FINAL REPORT

Standard Project Flood Analysis and
Conceptual Design of Channelization
in the Agua Fria River

Flood Control District of Maricopa County
2801 -3335 West Durango
Phoenix, Arizona 85009

Simons, Li and Associates, Inc.
P.O. Box 1816
Fort Collins, Colorado 80522

Figure 5.3. Sketch of 10" El Paso gas pipeline crossing of the Agua Fria River near Buckeye Road.

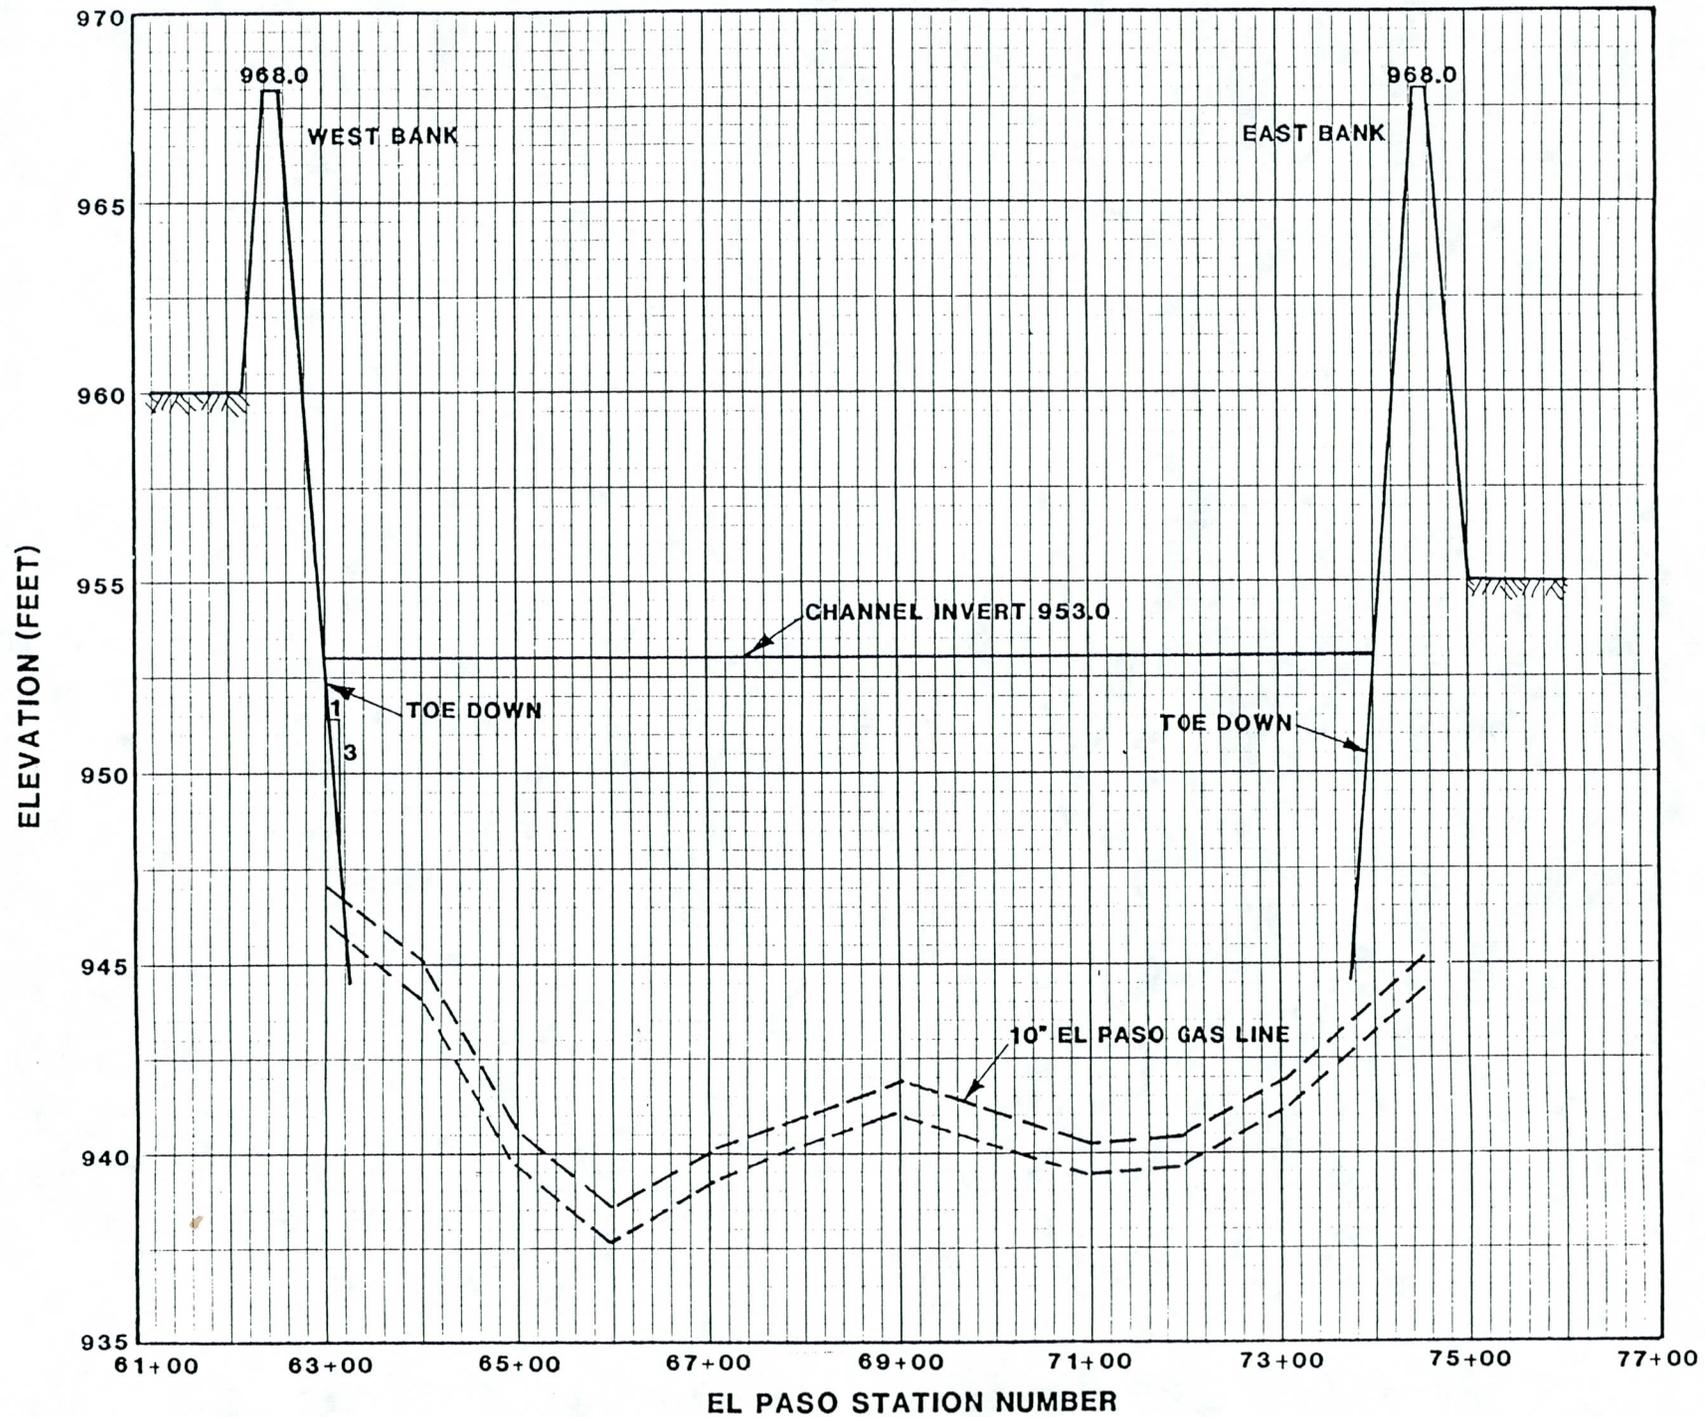
| 11. | Page 5.15: Reference is made to Figure 5.3 which was not included in the report. Include Figure 5.3 in the Final Report. |

Figure 7.5 Plan and elevation view of proposed grade control.

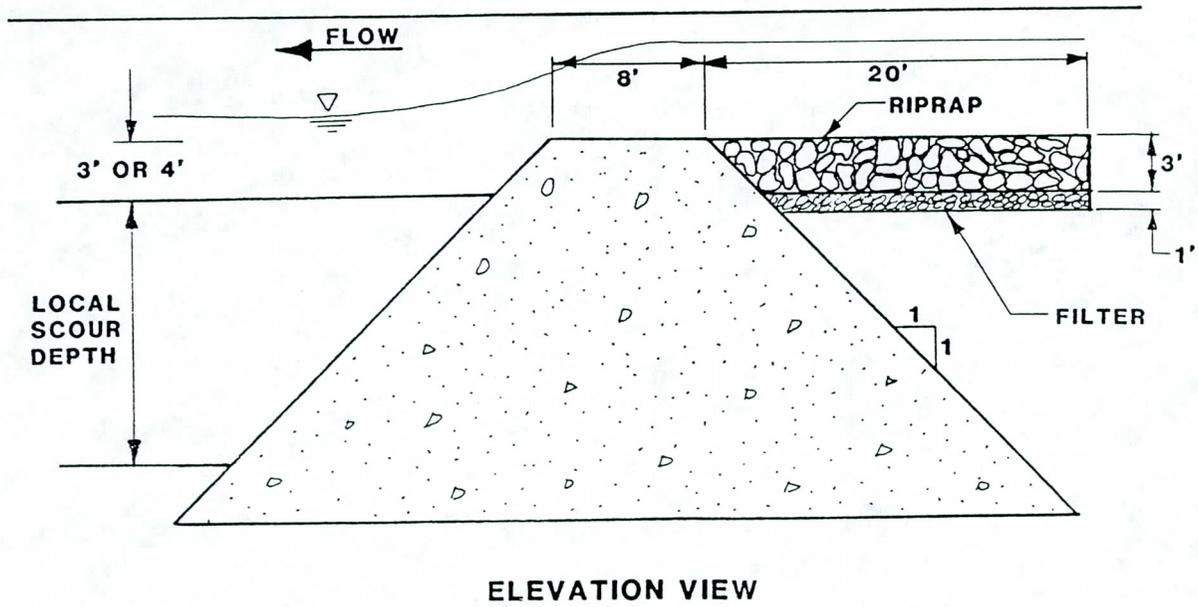
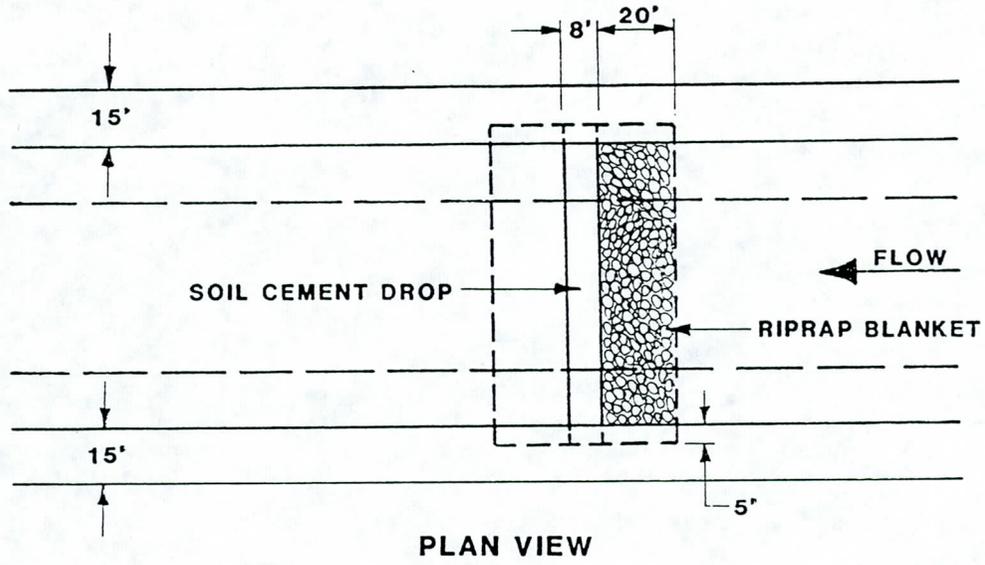
14. Figure 7.5, page 7.15: on the profile, the top of the depressed section is missing. If possible, put all of Figures 7.5 and 7.6 on one page.
15. Page 7.22, Paragraph 7.2.4.5: Since the SPRR piers are buried 30 feet below invert and scour is 21 feet, is it necessary to protect them? We need to clarify our recommendations for the final report.

Response: More extensive detailing of drop structures will be included in the final design. Figure 7.5 was added to the report and it shows elevation and plan views of the proposed soil cement drop structures. A discussion of factors considered for soil cement drop structures was added in Section 7.2.2.2.

Figure B.2. Proposed bed profile, equilibrium bed profile, SPF water-surface elevation, levee height and toe-down depth between Thomas Road and ISRB.

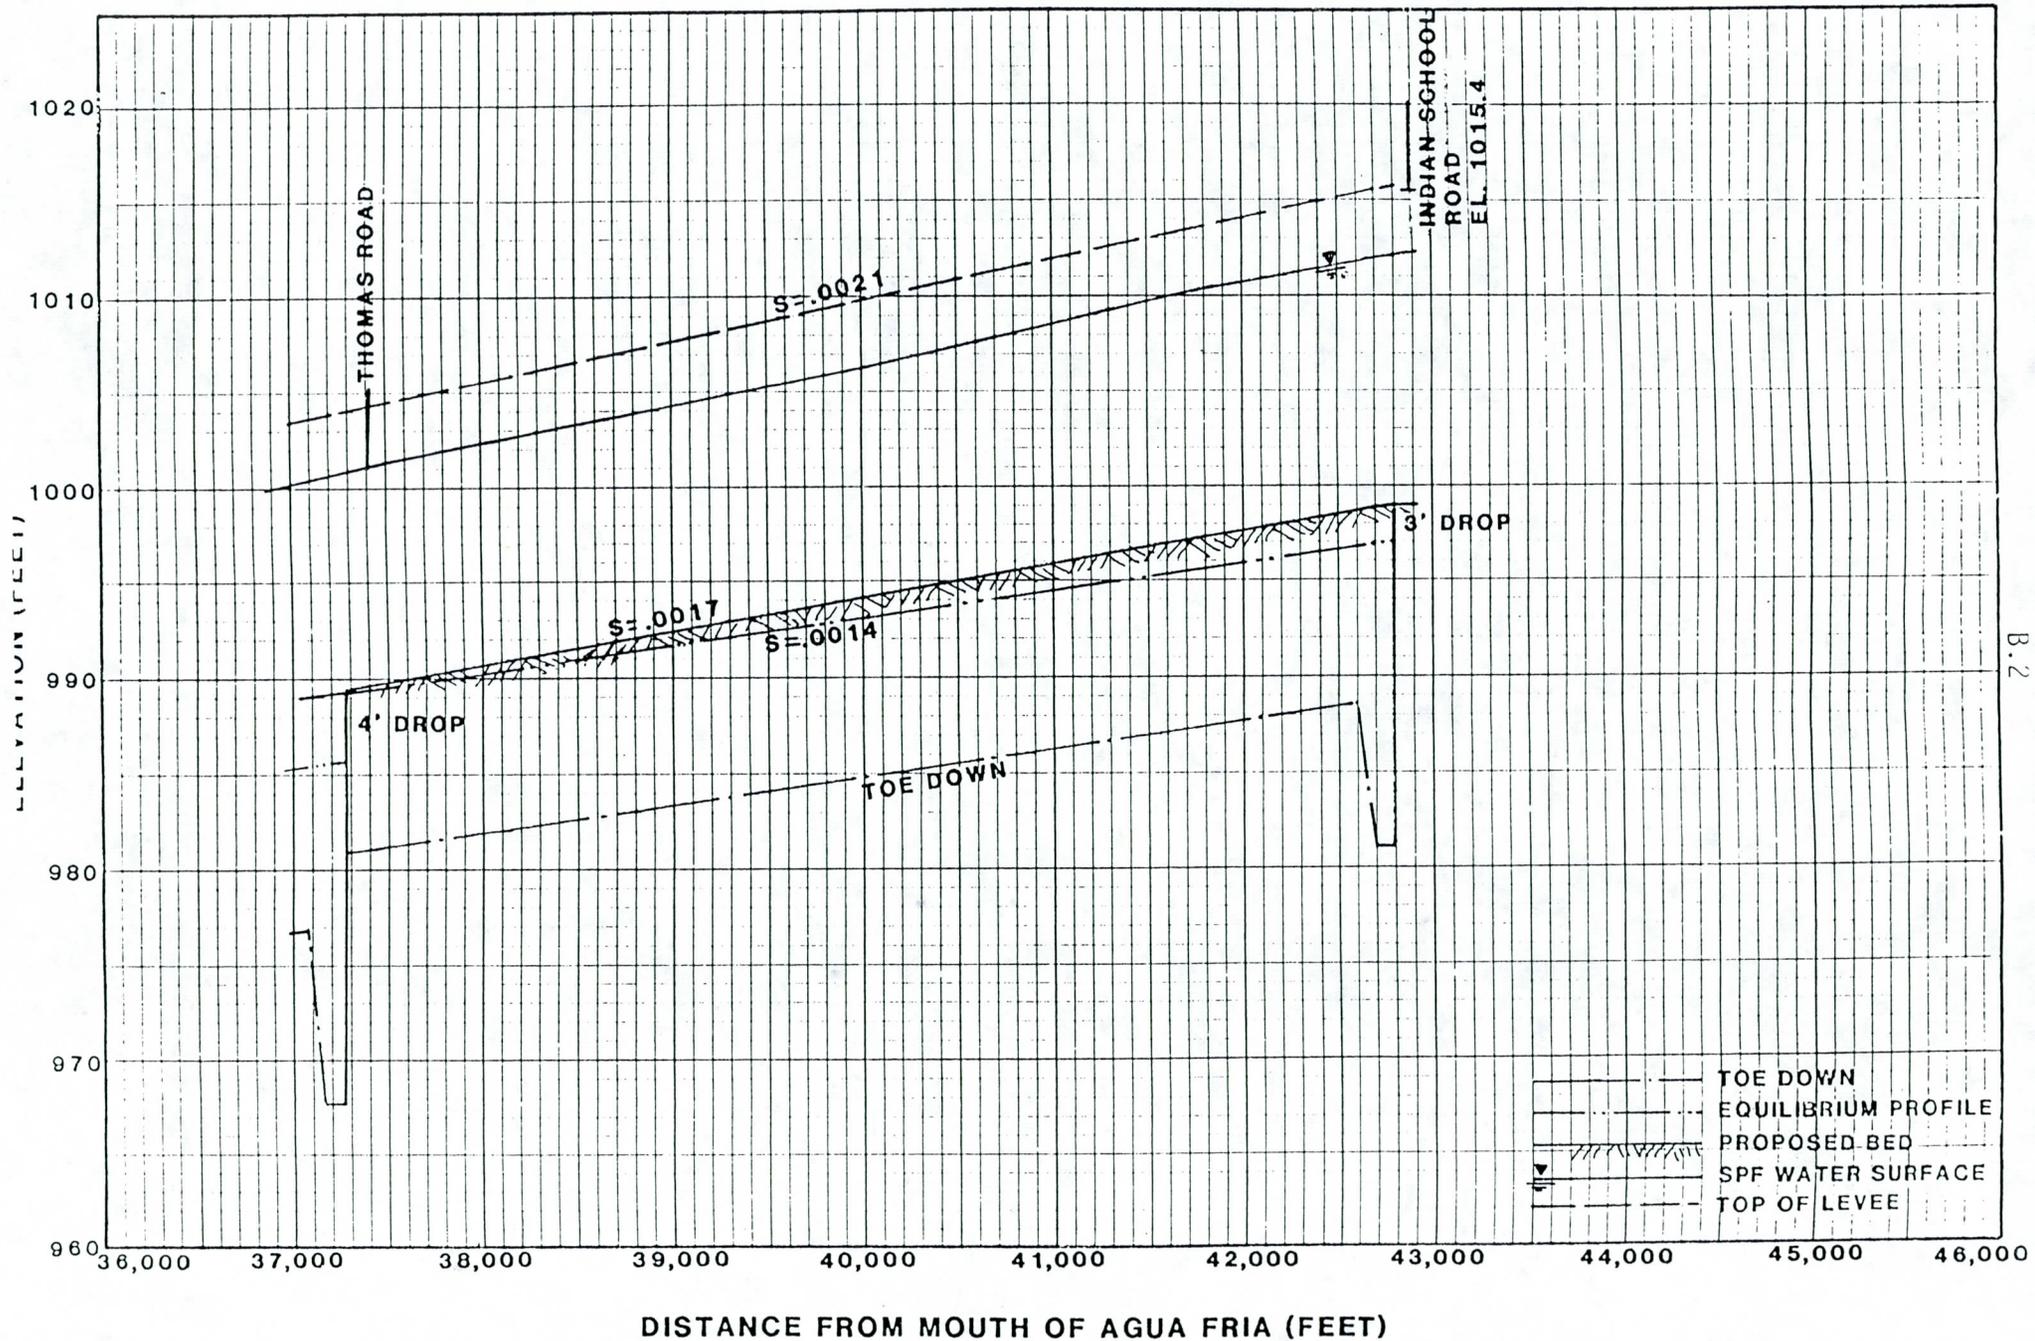
23. General Comment: If known, locations for drainage, culverts, etc. should be shown on all plates.
24. Figure B.2: Elevation scale on left of figure is incorrect. Elevation 980 was deleted.
